RE: Telesto/LRM comments on DRMS AM-4 application – Home Office Mine, Permit M1977-439

This letter is in response to the specific comments and questions in your letter of February 25, 2022, documenting comments on behalf of Loveland Ready-Mix Concrete, Inc. (LRM) on Exhibit G of Martin Marietta's 112c Permit Amendment Application (AM4) for the Home Office Mine, submitted on December 23, 2021, File No. M-1977-439. Below are your comments followed by Martin Marietta's responses.

EXHIBIT G: WATER INFORMATION

TAFT HOME OFFICE AMENDMENT EXHIBIT G

Chart 2: Martin Marietta Monitoring Data (HO-1 and HO-6)

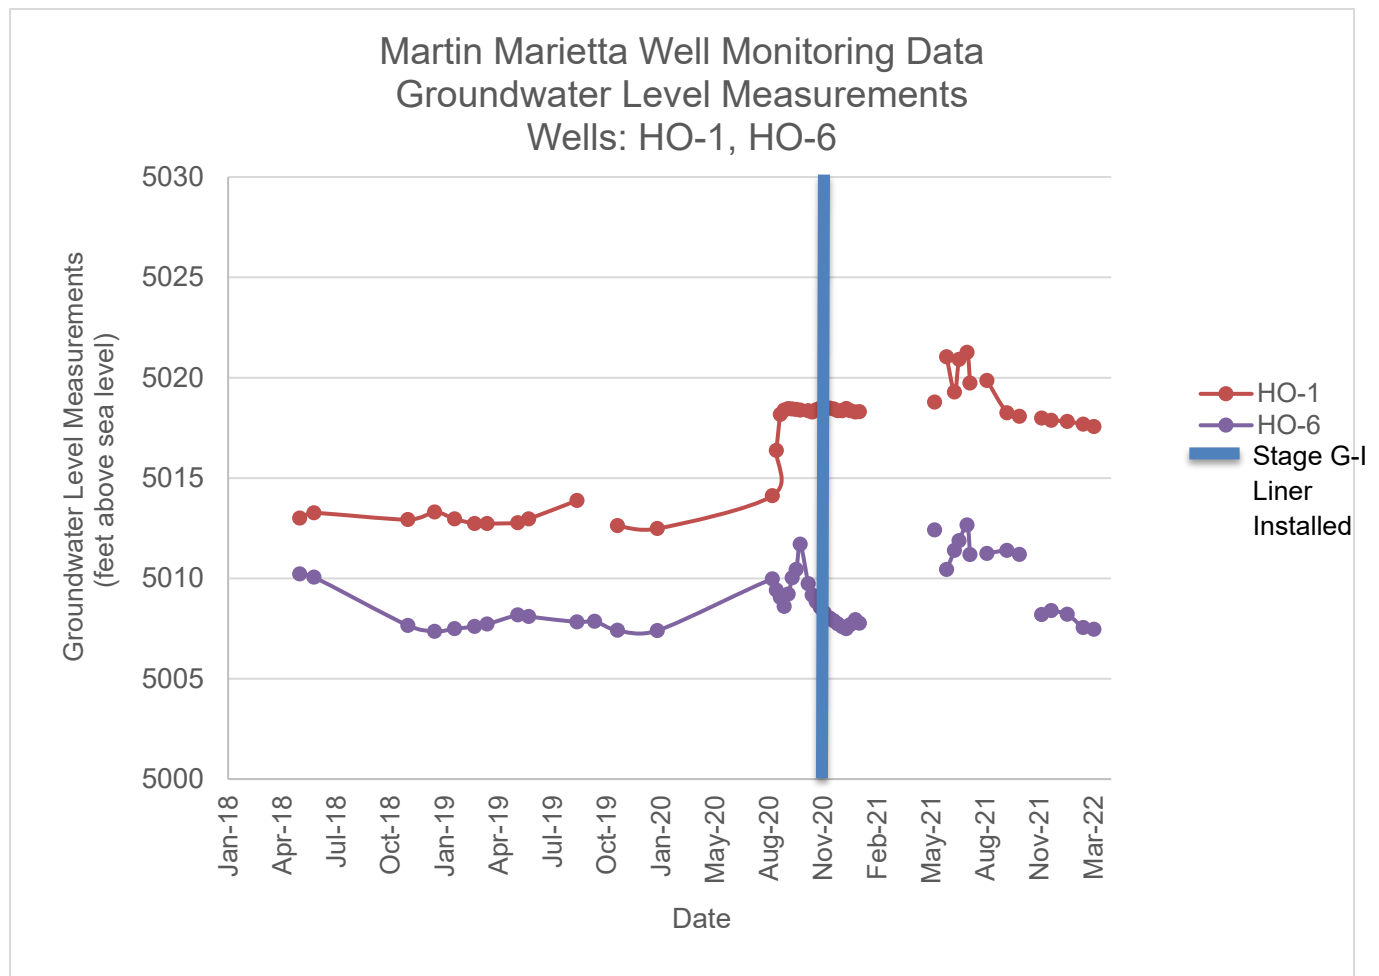
Chart 1 shows a steep rise that correlates in time to the end of mining in Phase 1. There is almost a 7.25 foot between July 2020 and July 2021 in well HO-01, and the trend is upward. What is the cause of this? Will the trend continue upward? This could be an issue for LRM's ability to farm the field to the north of Phase 1. Could it explain the issue raised by the neighbor?

Chart 1 from the original AM-04 document was renamed Chart 2 because of the addition of information to Exhibit G. Chart 2: Martin Marietta Monitoring Data (HO-1 and HO-6), previously named Chart 1: Martin Marietta Monitoring Data (HO-1 and HO-6) shows the upward trend referred to in the above comment. The increase in water level correlates to the installation of the Area G-I compacted clay liner. Since the original submission of AM-04, water level monitoring has continued. The hydrographs in revised Exhibit G include water level monitoring through March 2022. Additional water level monitoring data indicate that water levels have appeared to stabilize and show responses to local recharge events.

Chart 6: Nearby Well Monitoring Data

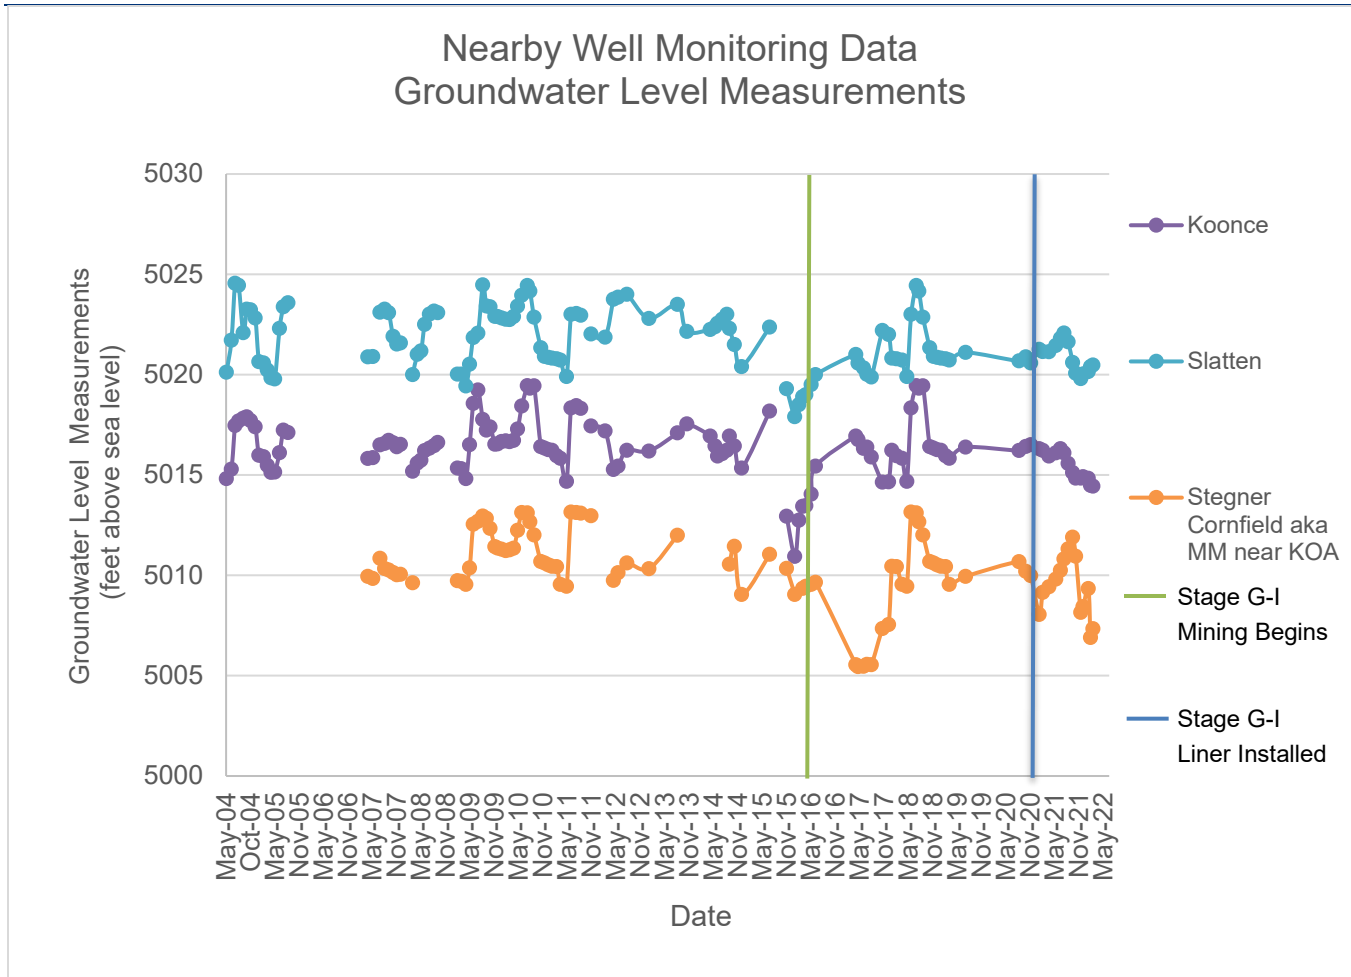
- How large will the mounding be on the north side of the Phase 1 pit?

Mounding on the north side of the Area G-I pit will likely be on the order of 2-3 feet, as shown in the Koonce and Slatten hydrographs in Chart 6: Nearby Monitoring Well Data.

G-1

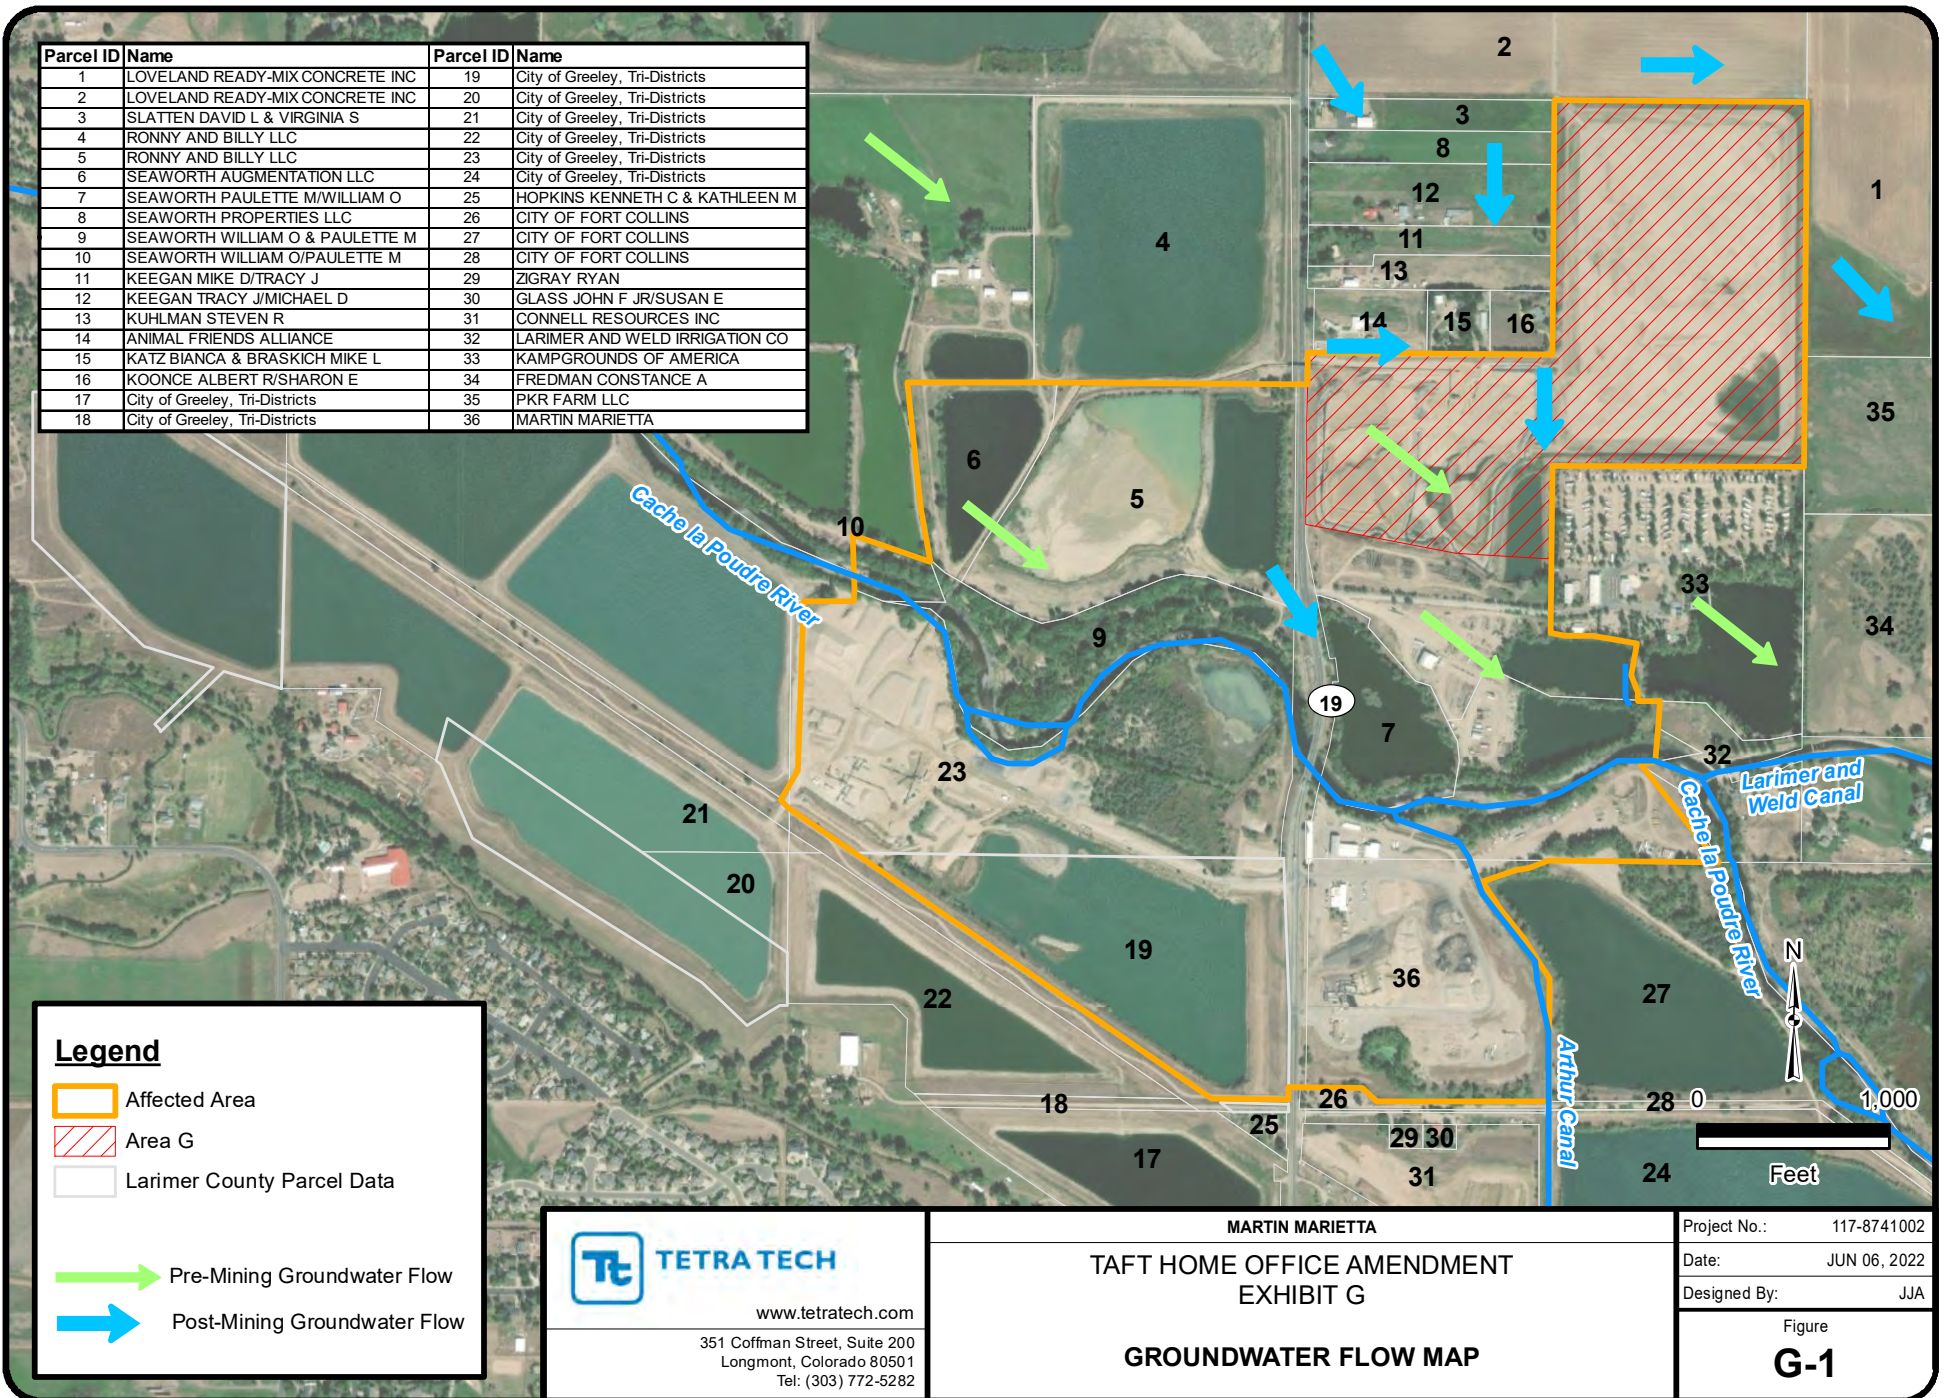
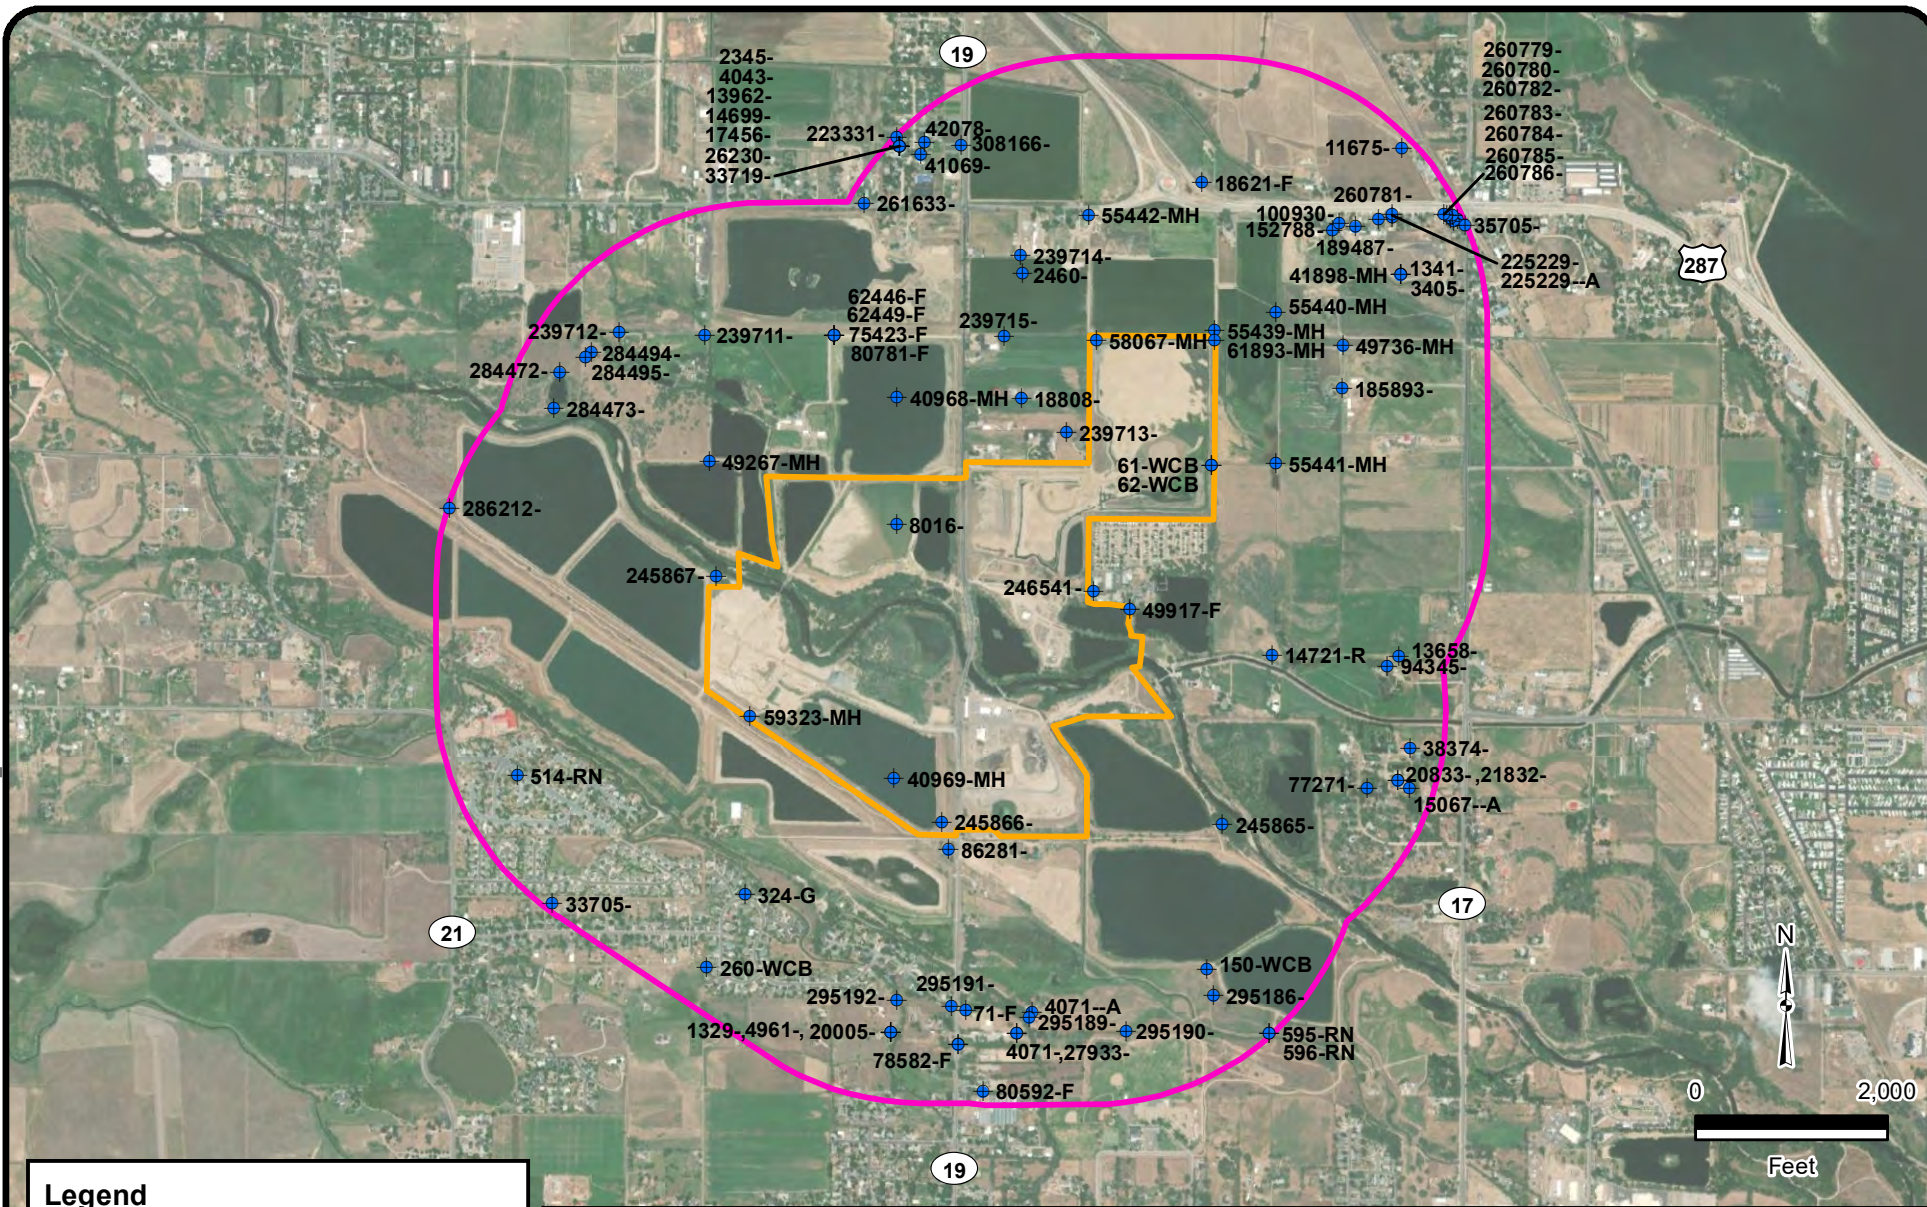
Paragraph 3 states that the discussion is limited to potential changes in the hydrologic balance resulting from the installation of the compacted clay liners. The paragraph refers to Figure G-1, which shows conceptual groundwater flow directions before mining and after reclamation. The focus of the paragraph and Exhibit G is on Stage G, yet the Stage G area is confined to the northeast corner of Figure G-1. It should be central to the figure to show areas surrounding the pit. With lined pits, the potential disruption to the hydrologic balance is "mounding" upgradient of the lined area and "shadow" of the down-gradient areas. Please provide projections of the anticipated changes up- (especially to the north) and down-gradient of the pit area. Also,

- What is the basis of the green flow arrows?

- How do you depict groundwater flow directions (they may be correct) without a potentiometric surface?

- Why are there no projections of the pre-pit groundwater flows through the pit area and to the north?

A well-understood characteristic of alluvial aquifers is that groundwater flows approximately parallel to river flow. The green flow arrows represent pre-mining groundwater flow patterns.

A well-understood characteristic of alluvial aquifers is that groundwater flows approximately parallel to river flow.

A revised Figure G-1 depicts additional groundwater flow arrows.
